City of El Paso – City Plan Commission Staff Report

Case No: SUSU15-00072 Copia Pond
Application Type: Resubdivision Combination
CPC Hearing Date: January 7, 2016

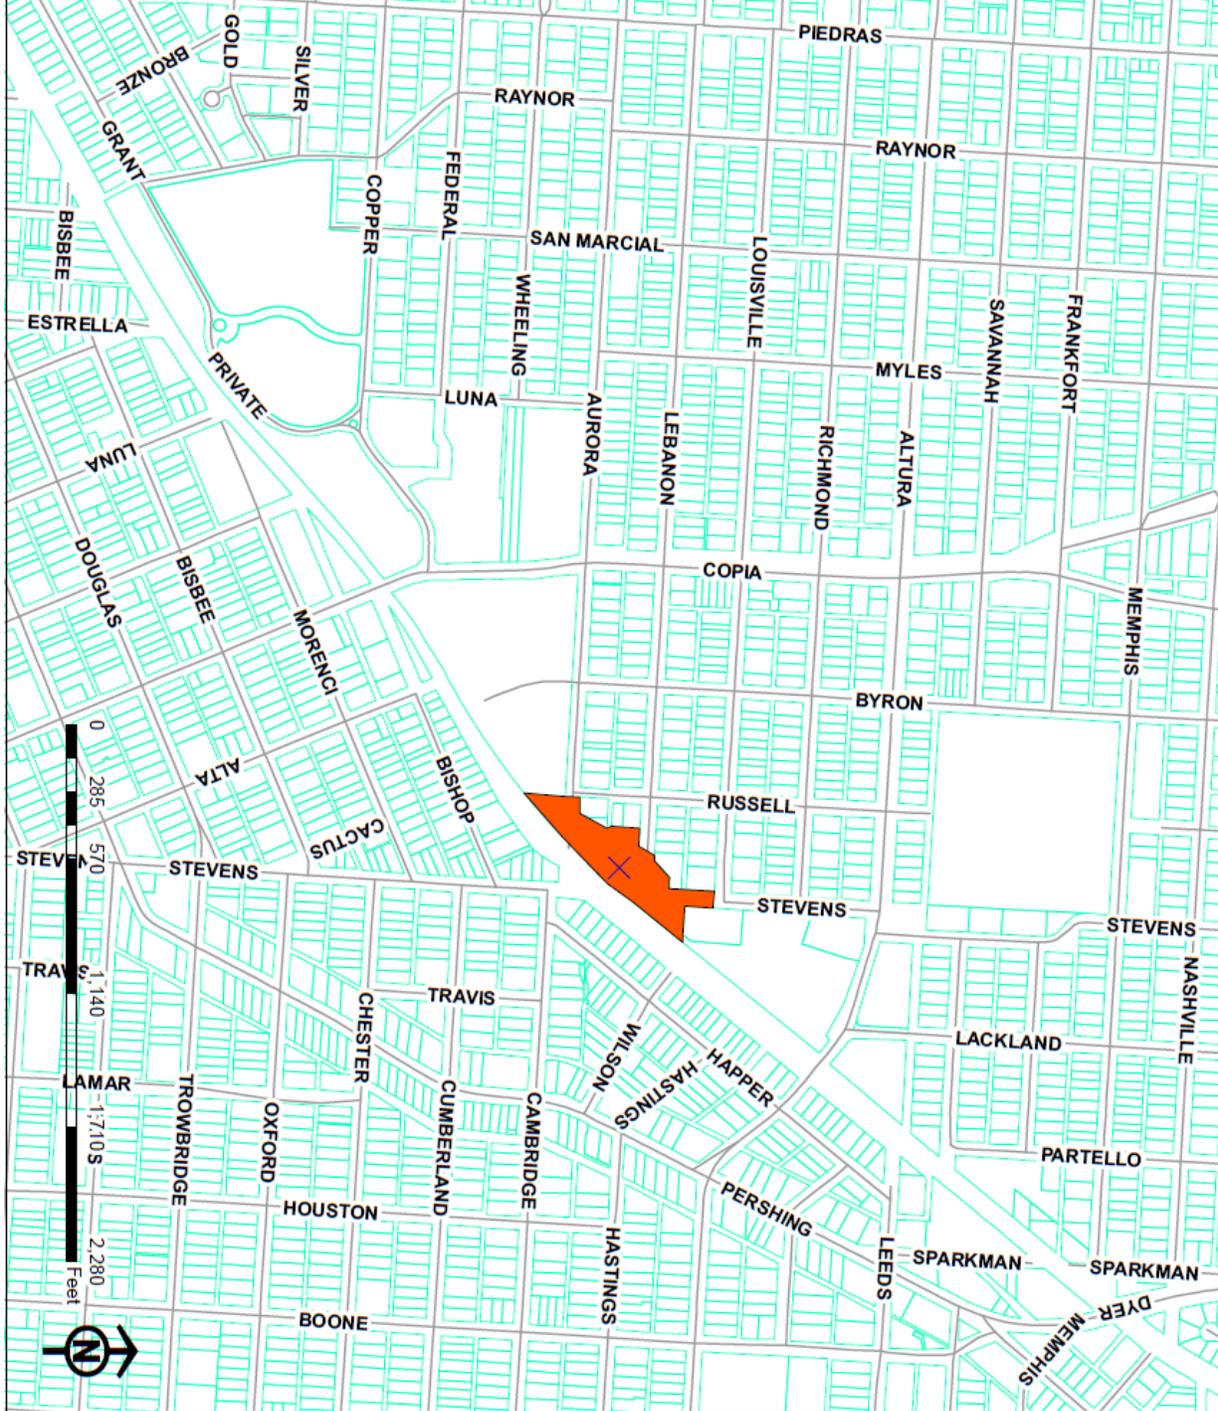
EPE requests to maintain easement rights of all existing lines, as shown in the attached image. If the lines are to be relocated please call in to 915-351-4224 to be assigned a Designer/Engineer who can assist in the design and removal of the lines.
